SITE SUPPLEMENTAL INSTRUCTION

PROJECT: Forestside Estates
Attmar & Palleschi Drive
Brampton, ON

SITE SI NO. M-7

PURPOSE: To revise make-up air risers to suit space requirements & City Permits comments.

DRAWN	CHECKED	SCALE
MC	LM	1:50
DATE	PROJECT	DRAWING
MAY, 2019	18-017	M-31A
		OF

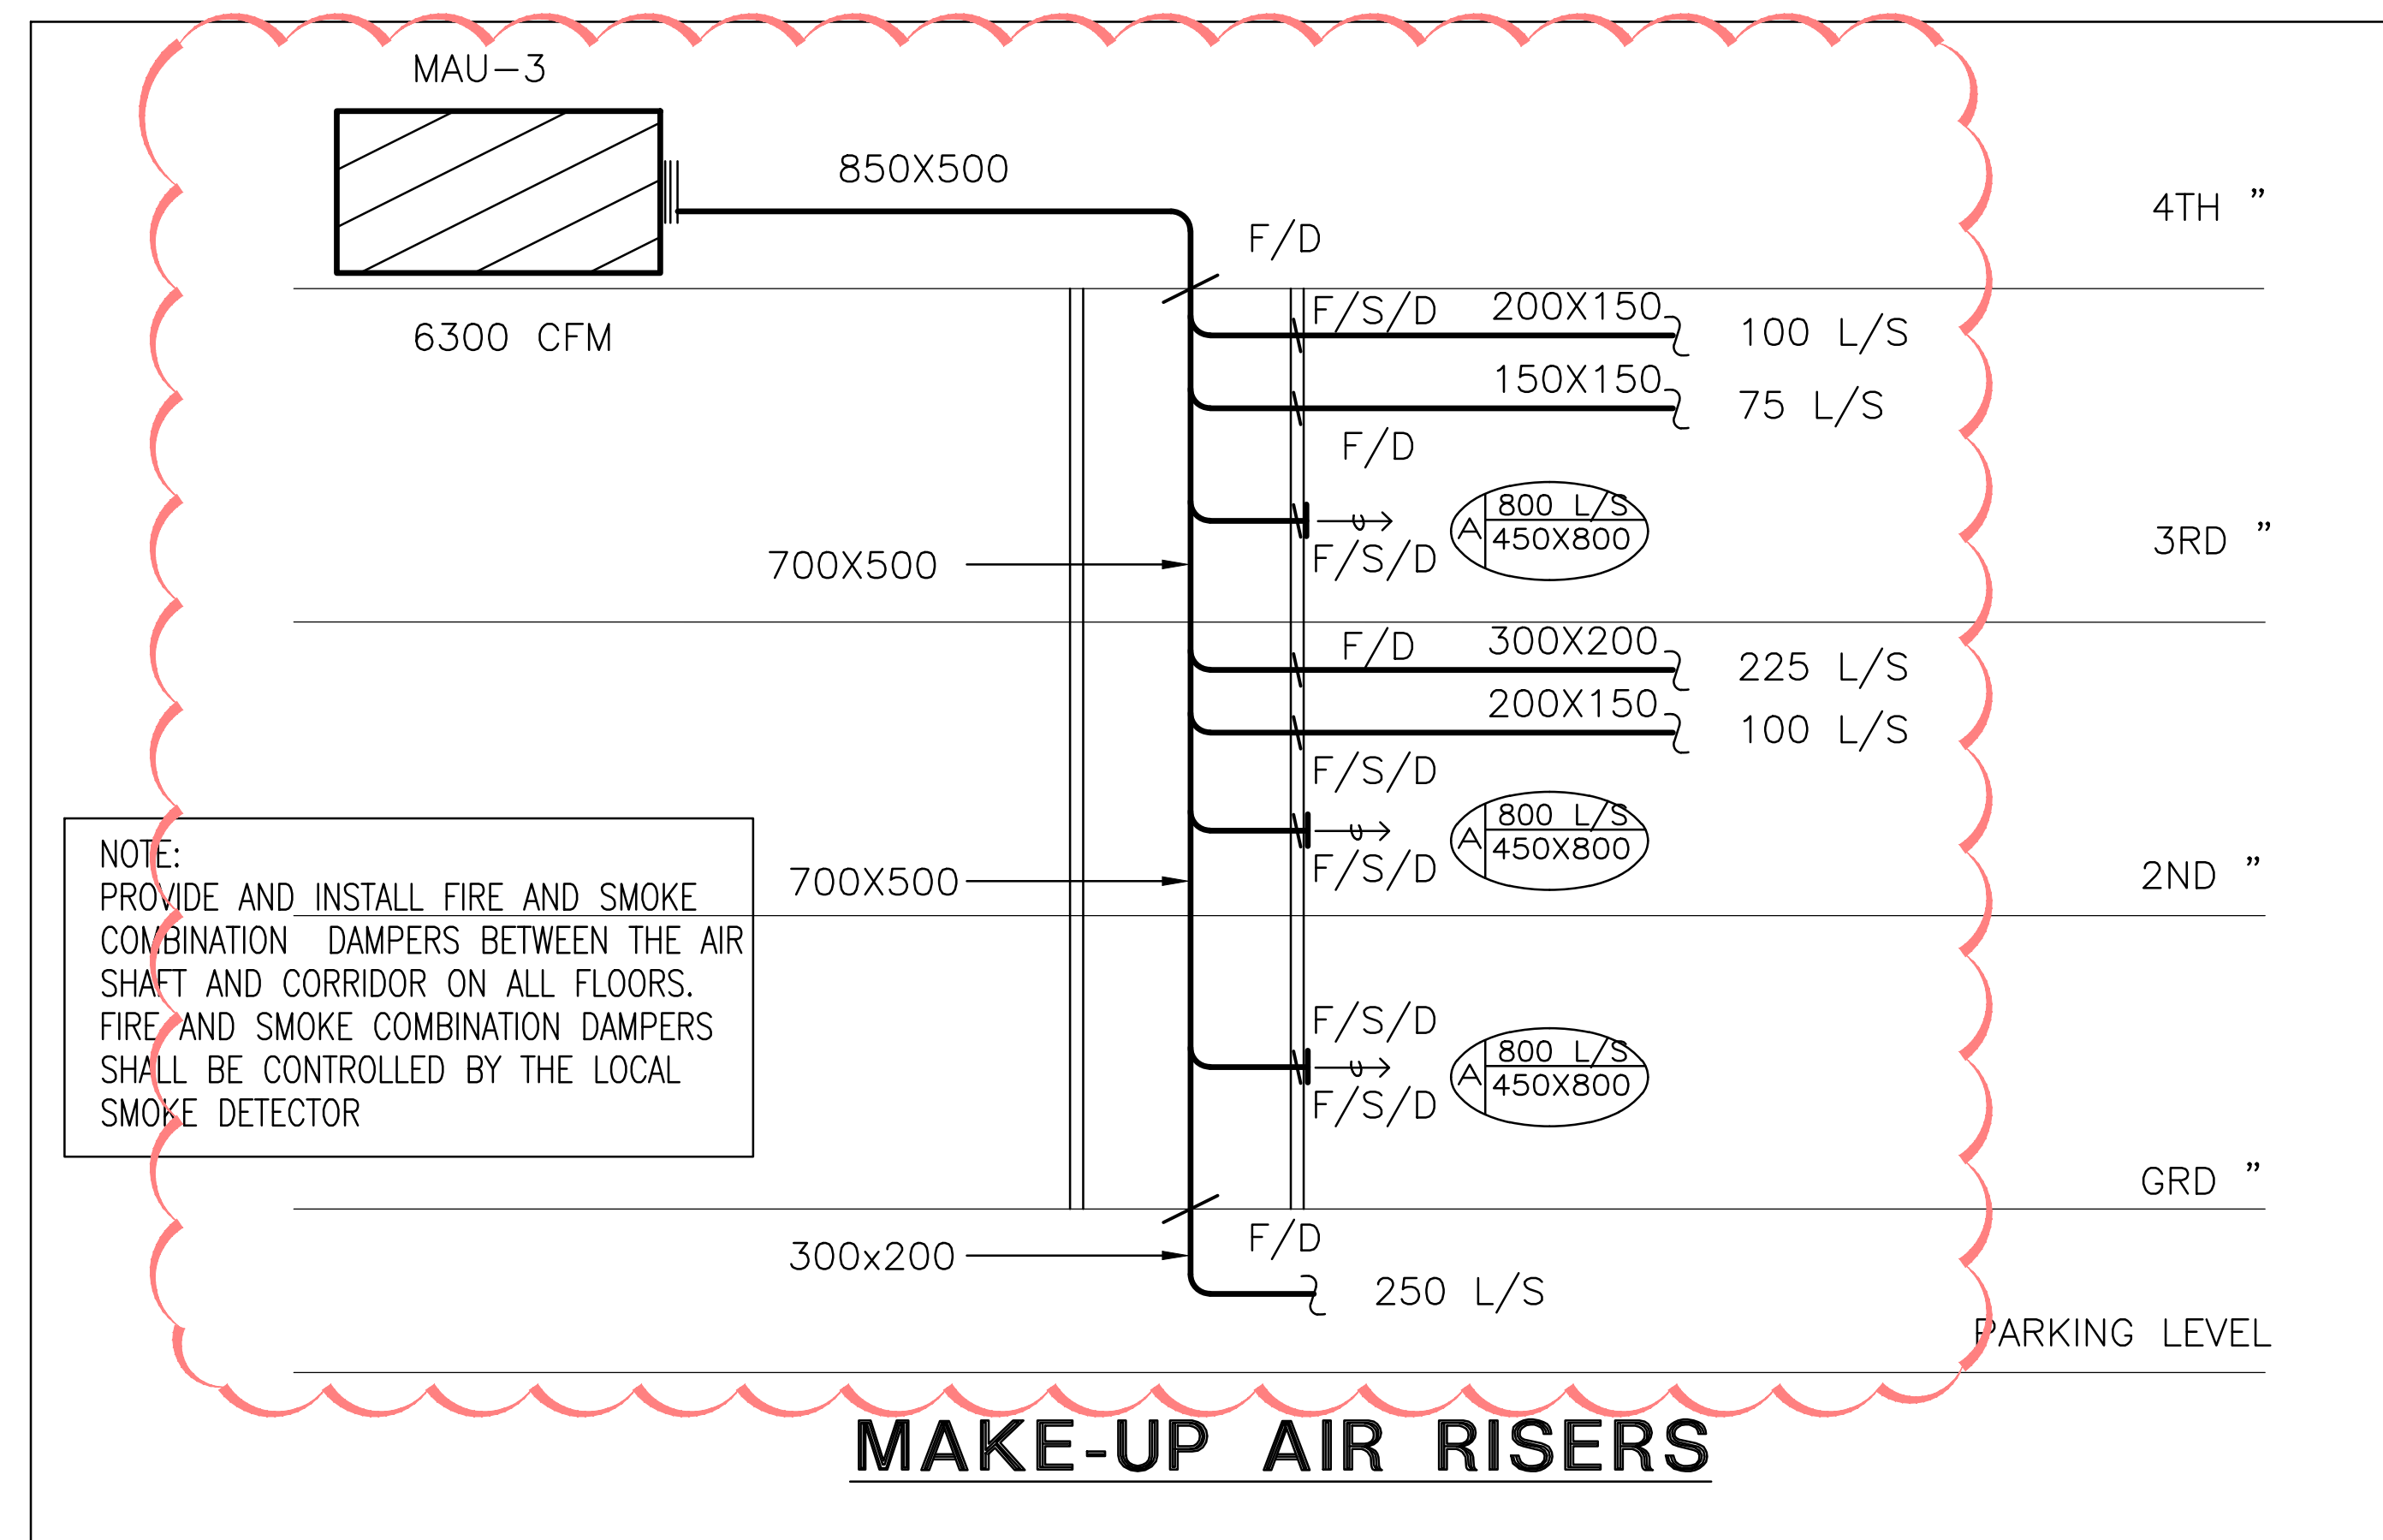
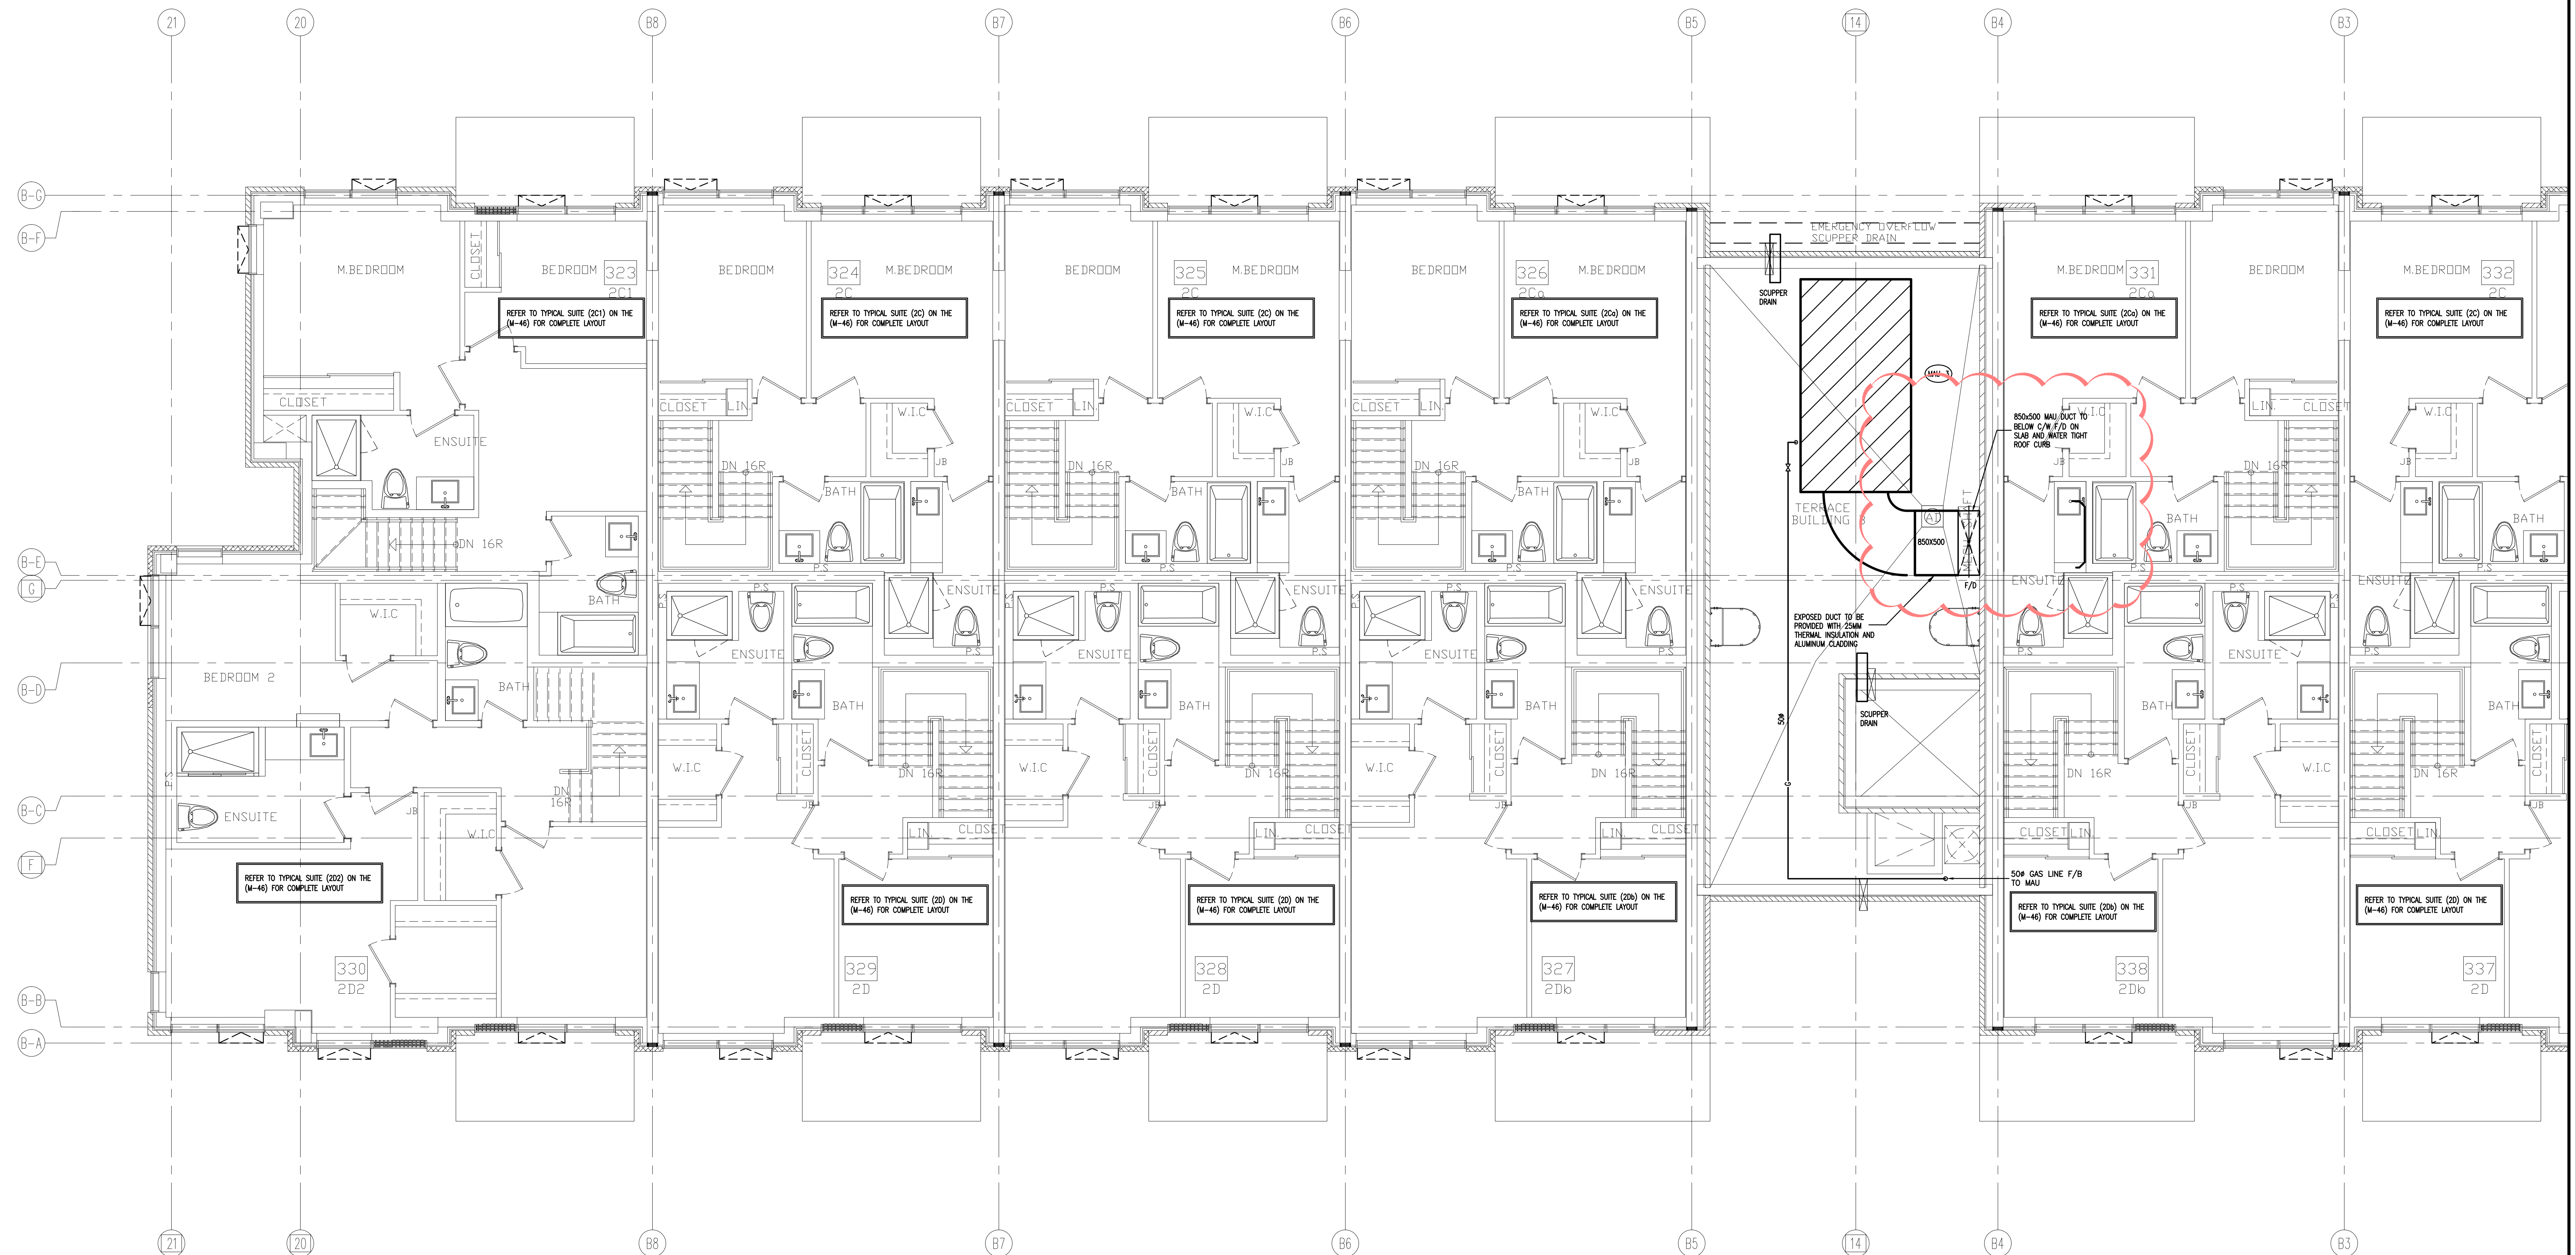
13.1 Clarify: Make-up air duct size.

13.2 Revise: Make-up air riser diagram.

DRAWN MC	CHECKED LM	SCALE 1:50
DATE MAY, 2019	PROJECT 18-017	DRAWING M-35A OF -

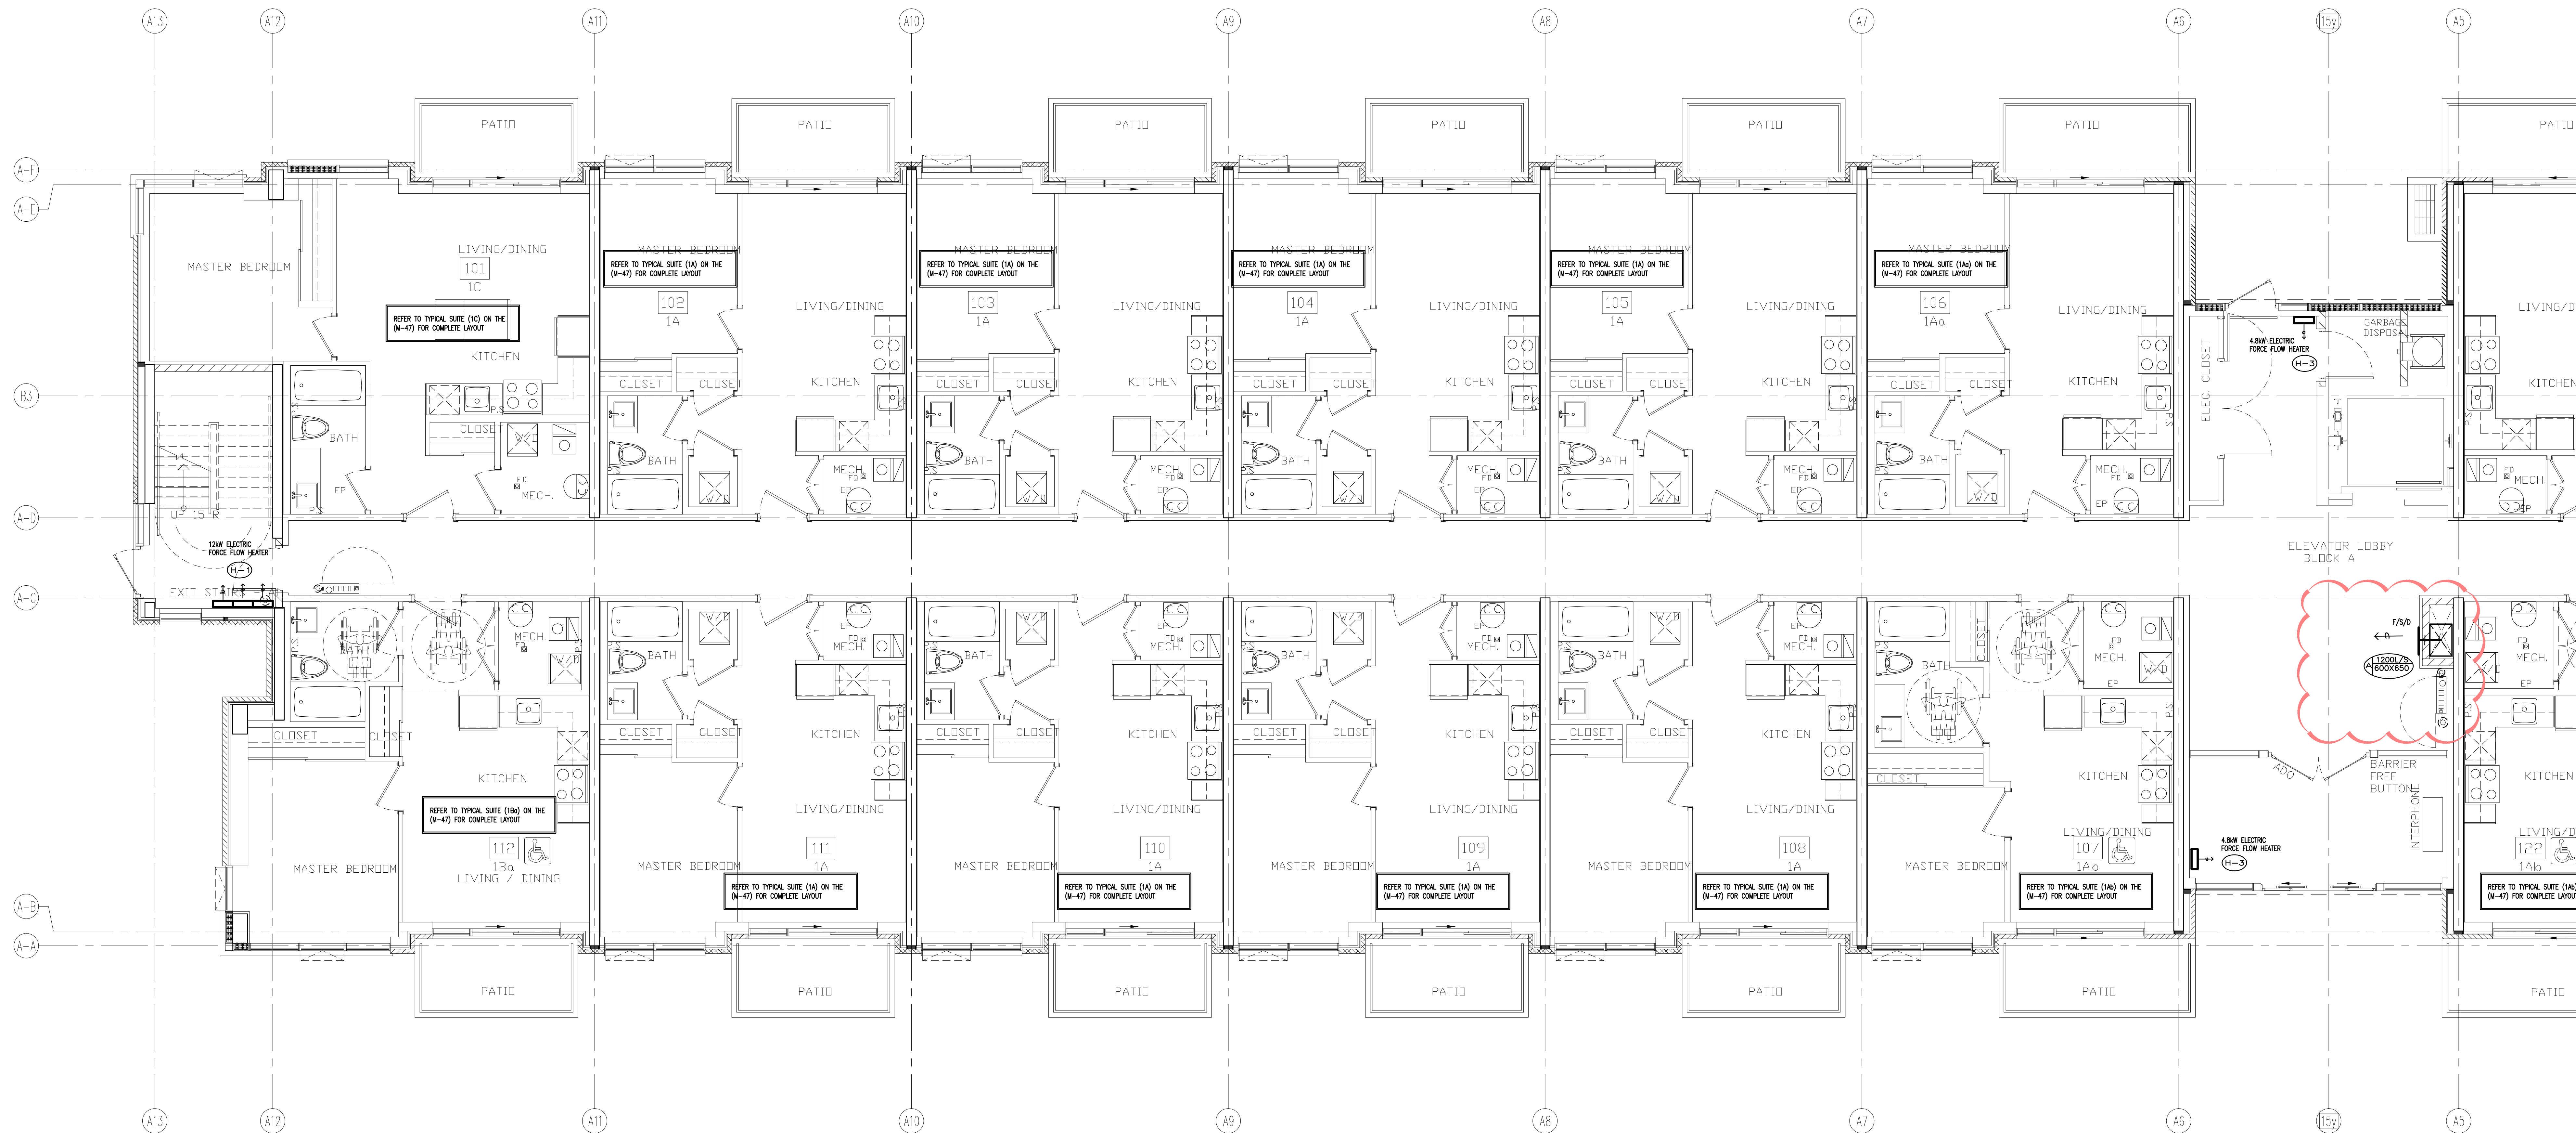
14.1 Clarify: Make-up air riser.
